GH5200 Product Change Notifications

Product change notifications (PCN) is a way of informing customers of upcoming changes related to Teltonika products. This includes outward appearance adjustments, hardware improvements, firmware changes, changes to package contents, etc. This page stores information regarding changes to the GH5200 tracking device. Below you will find a list of both upcoming and already implemented changes sorted from newest to oldest (top to bottom).

2021.09.23: Battery, GSM, GPS Text changed into graphic logos on the front cover

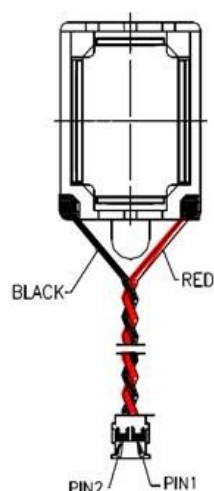
Battery, GSM, GPS Text changed into graphic logos on the front cover

Change reasons	Logos is more understandable and can be used for 2G and 4G devices	
Affected products		
Model	Affected order codes	Order code changes
GH5200	GH5200*****	No changes
Change impact		
Risk assessment	No risk factors encountered with this change	
Suggested implementation plan	No actions required.

2021.08.25: Changed speaker's connector

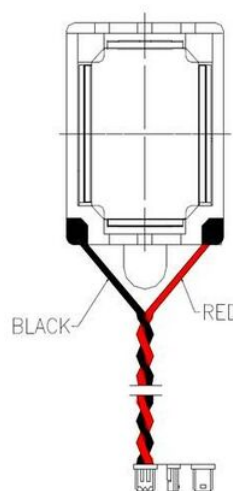
Change type	Hardware
	Connector type of the speaker has been changed

Change reasons	Improved connection stability and vibration resistance.	
Affected products		
Model	Affected order codes	Order code changes
GH5200	GH5200*****	No changes
Change impact		
Risk assessment	No risk factors encountered with this change	
Suggested implementation plan	No actions required.
